Appendix B

Detailed Response to Submissions

1.1 Department of Planning, Housing and Infrastructure

Figure 1: Building separation

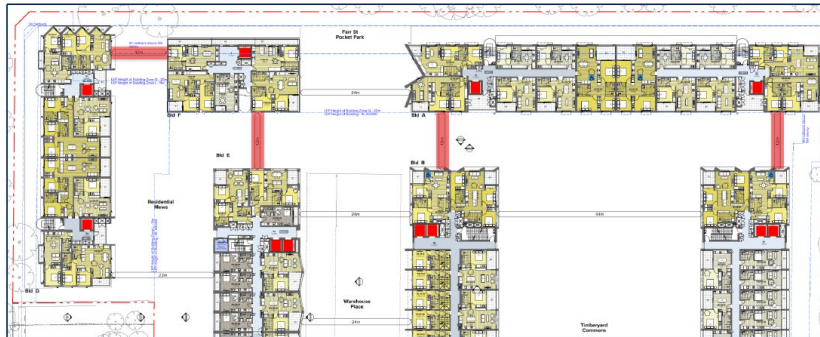
Compliance with Apartment Design Guide (ADG) with building separation was raised an issue during both State Design Review Panel sessions. The project currently has unresolved non-compliances between buildings A, B, E, F, and G (Figure 1). Provide amended plans with greater building separation or implement appropriate mitigation measures to ensure a satisfactory level of amenity for the affected apartments.

Amendments have been made to the façade of the identified buildings to achieve the ADG objective for privacy. Refer to the revised Architectural Drawings at **Appendix C** and the ADG Compliance Assessment contained within the revised Design Report at **Appendix F**.

Figure 2: Additional view point

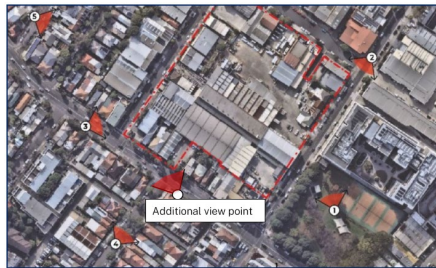
Include an additional view point from the eastern corner of Frampton Ave and Sydenham Road looking toward Building G as shown in Figure 2. Building G proposes the largest variation to the maximum height of buildings development standard and is directly opposite to a low height residential zone.

A revised Visual Impact Assessment has been prepared by Ethos Urban at **Appendix H**, to include the additional viewpoint requested with a photomontage of the proposed development. Further discussion is provided in **Section 3.3.3** of the RTS Report.

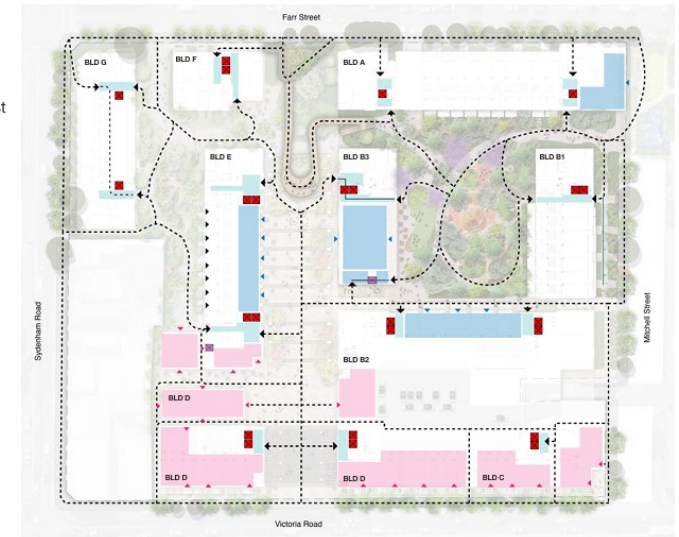
Additional details indicating extent of accessible pedestrian movement network across internal site are to be provided, with potential obstacles to be identified e.g. wheelchair access along proposed footpath on Mitchel Street

The Design Report at **Appendix F** provides a detailed overview of the accessible pedestrian movement network, refer excerpt below.

Figure 2: SVPA Victoria Road/ Sydenham Road Intersection Layout

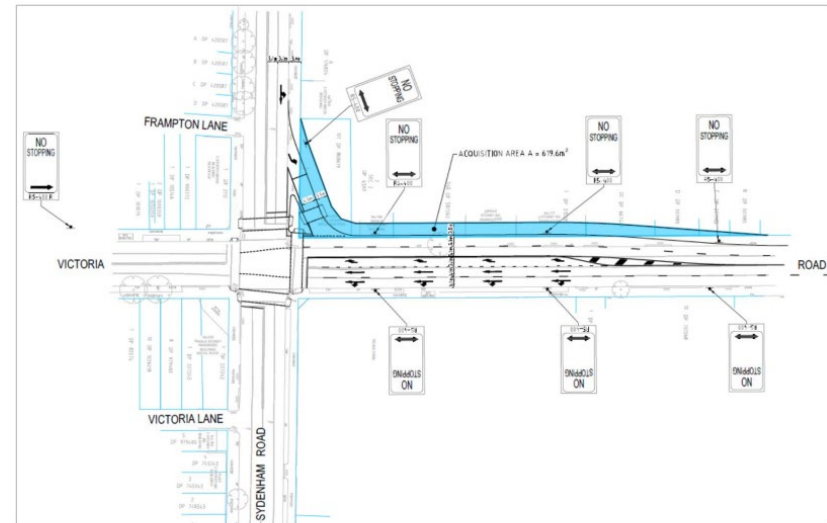
There has been several revisions to the Victoria Road/ Sydenham Road intersection layout however, it is understood that the intersection upgrades

required under the SVPA included a dedicated right turn bay on Victoria Road (north) and left turn slip lane on Sydenham Road (west) only, with the approved layout shown in Figure 2. It is understood that the SVPA at the time did not formally include provision of right turn bays on Sydenham Road. The original SVPA upgrades (prior to their removal from the SVPA) were also confirmed by TfNSW, as detailed in Attachment 1.
